**CENTER FOR DRUG EVALUATION AND
RESEARCH**

212905Orig1s000

OTHER REVIEW(S)

MEMORANDUM
RESPONSE TO HUMAN FACTORS ADVICE MEMO
Division of Medication Error Prevention and Analysis 1 (DMEPA 1)
Office of Medication Error Prevention and Risk Management (OMEPRM)
Office of Surveillance and Epidemiology (OSE)
Center for Drug Evaluation and Research (CDER)

Figure 1: Outer protective tube, applicator, and break tool

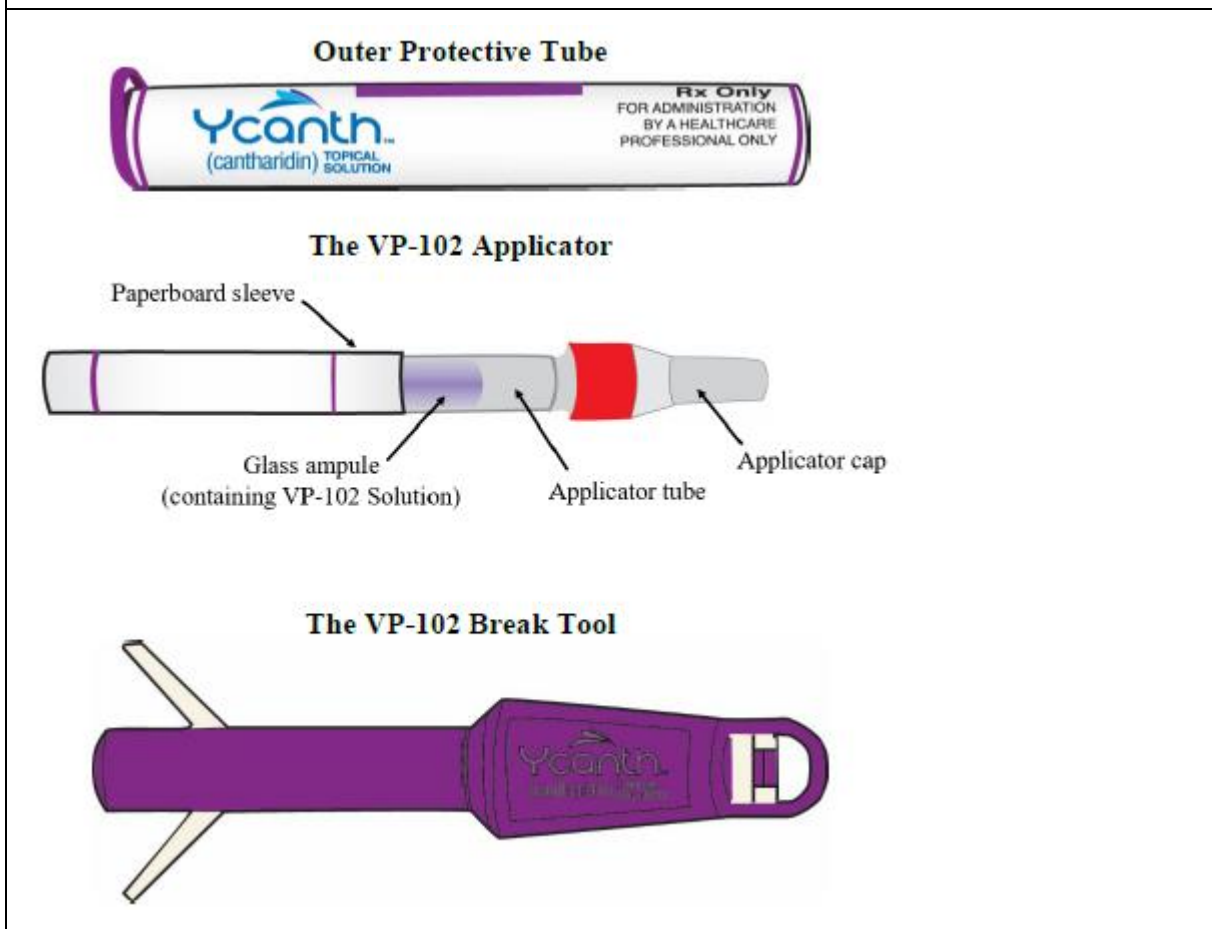
<p>Based on our overall assessment, we disagree with the Applicant that no additional mitigations are required to further mitigate this risk. As such, we find that the container label and carton labeling can be improved to further mitigate risk of failure to put on PPE. We provide a recommendation in Table A to address this concern.</p>

Single Tube Applicator Label			
1.	IFU includes the instruction to break the ampule using the break tool but single tube applicator label does not include the instruction to break the ampule using the break tool.	We are concerned that the user interface is not optimized and there is a risk of toxic solution getting in patient's or user's open wound resulting in pain, burning, and increased risk of systemic exposure if the user breaks the ampule by hand or with another tool.	Add "Must break the ampule using the enclosed break tool" statement on the single tube applicator label to ensure break tool is used to break the ampule.

1.	Your paperboard sleeve container label is not consistent with your IFU with regards to the instruction to inspect the applicator. The IFU states, "Inspect the VP-102 Applicator for the following types of damage" while the paperboard sleeve container label states, (b) (4) [Redacted] [Redacted] [Redacted] [Redacted]	Inconsistencies between container label and IFU with regards to the instruction to inspect the applicator may lead to misinterpretation.	To be consistent with IFU, revise statement (b) (4) [Redacted] [Redacted] to "Remove paperboard sleeve and inspect <u>the applicator</u> before using break tool." Additionally, add more emphasis to the instruction to inspect the applicator on paperboard sleeve label.

Break Tool Carton Labeling			
1.	Your break tool labeling is misleading because it includes the YCanth proprietary name.	We are concerned users may misinterpret the labeling to mean that the break tool carton contains drug product.	To decrease the risk of medication error, we recommend you remove the proprietary name from the break tool carton labeling or emphasize that this is the Break Tool for use with Ycanth.
